Annual Monitoring Report

Middle South Muddy Stream Restoration Site

Subject: Revisions to Middle South Muddy Restoration Monitoring Year 3 (MY3) Report; NCDMS Project #93875

Figure 2. Integrated Current Condition Plan View

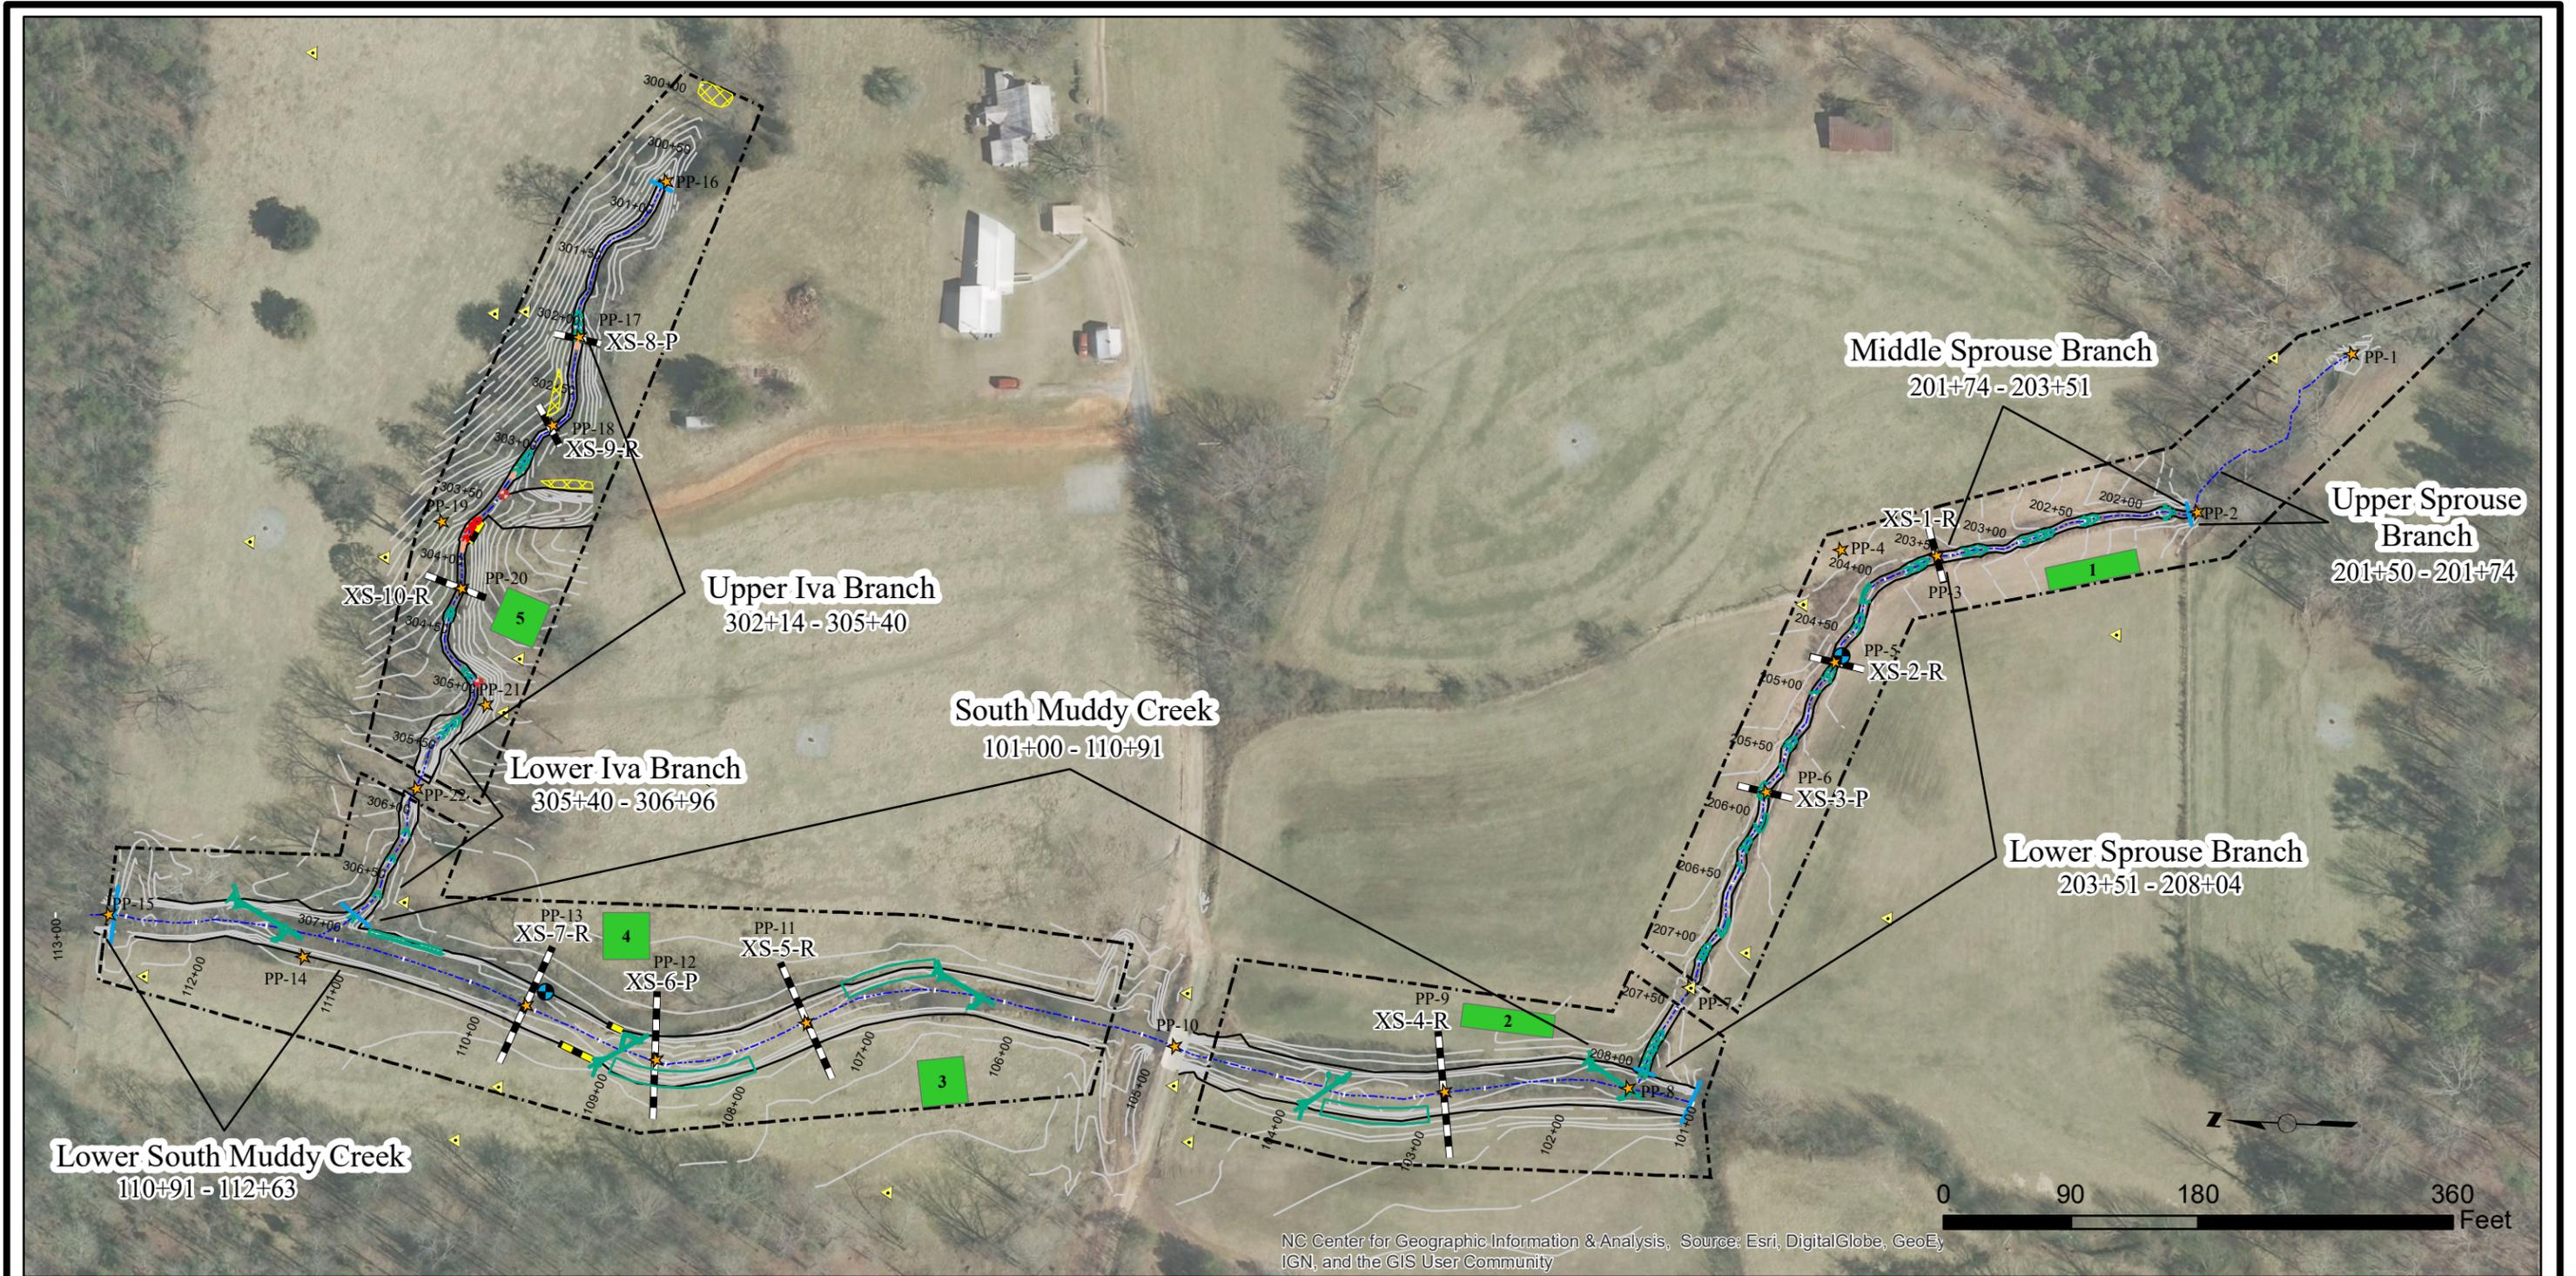
- Please add the locations of the two continuous gauges on Iva Branch. **The continuous stage recorders have been added to the CCPV.**

Middle South Muddy Iva Branch Perennial Gauge

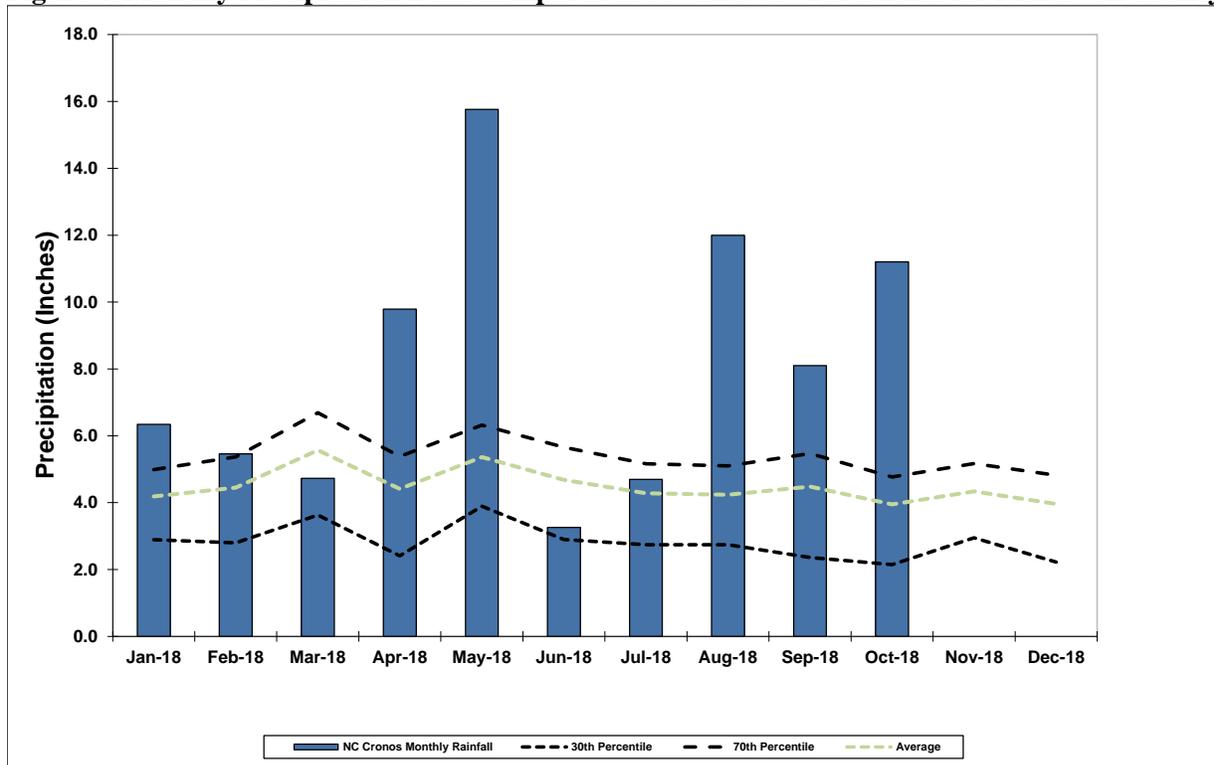
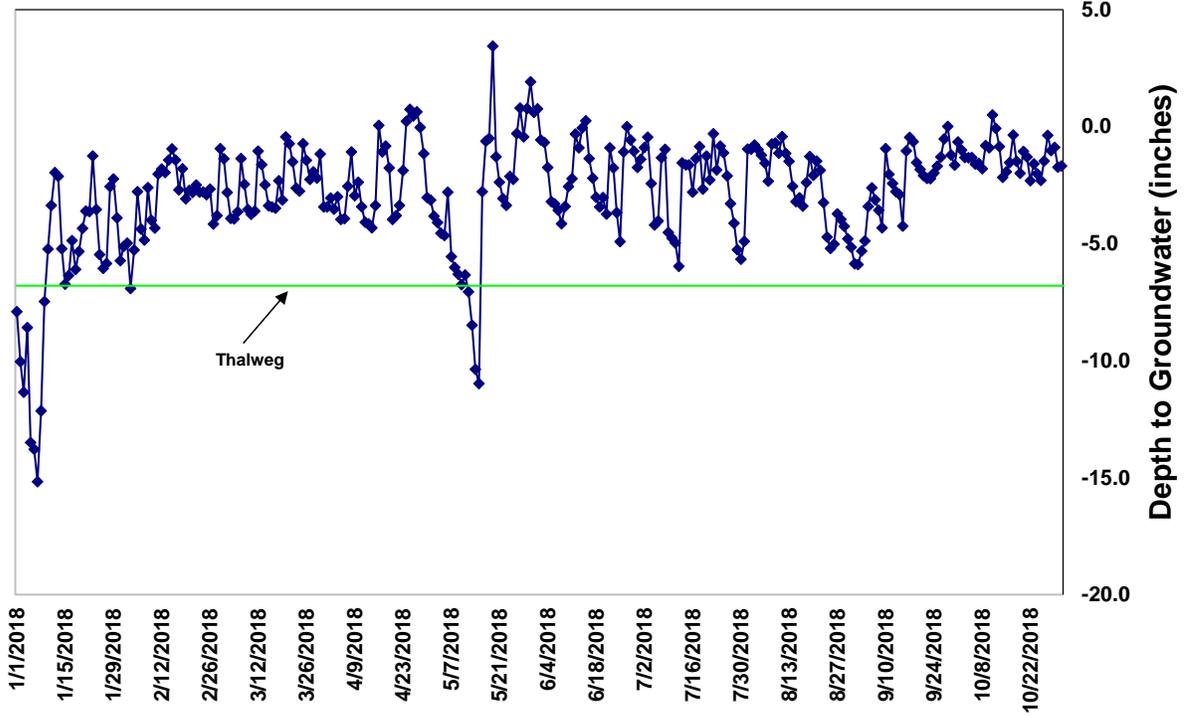
- Please include the continuous stage recorder data for the two gauges on Iva Branch. **The two continuous stage recorder plots have been added to Appendix E.**
